APPLICATION FOR PERMIT TO DRILL OR REENTER

2. Name of Operator CIMAREX ENERGY COMPANY (215099)		8. Lease Name and Well No. VACA DRAW 20-17 FEDERAL 57H (319775)
3a. Address 600 N. Marienfeld St., Suite 600 Midland TX 79701	3b. Phone No. (include area code) (432)620-1936	9. API-Well No. 30-025-46119 (97994)

APPROVED WITH CONDITIONS
Approval Date: 05/24/2019

Figure 1. Cross-sections and plans for typical road sections representative of BLM resource or FS local and higher-class roads.

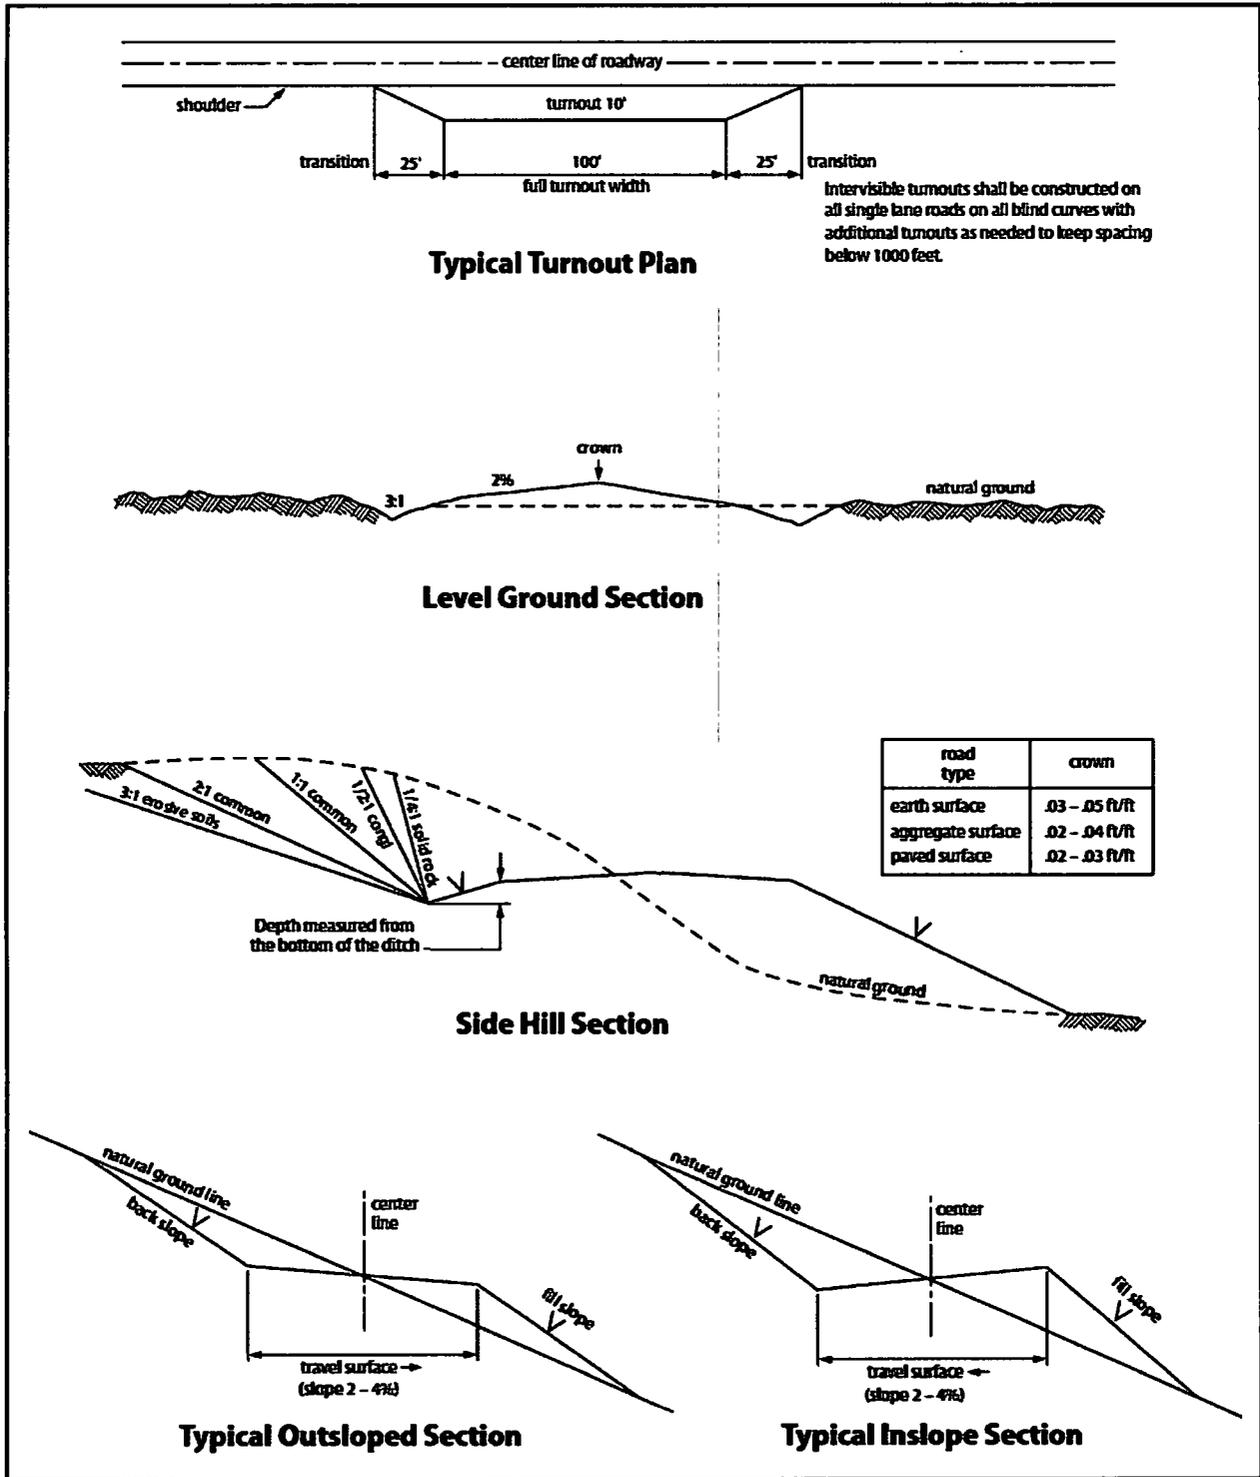
Crowning shall be done on the access road driving surface. The road crown shall have a grade of approximately 2% (i.e., a 1" crown on a 14' wide road). The road shall conform to Figure 1; cross section and plans for typical road construction.

Vehicle turnouts shall be constructed on the road. Turnouts shall be intervisible with interval spacing distance less than 1000 feet. Turnouts shall conform to Figure 1; cross section and plans for typical road construction.
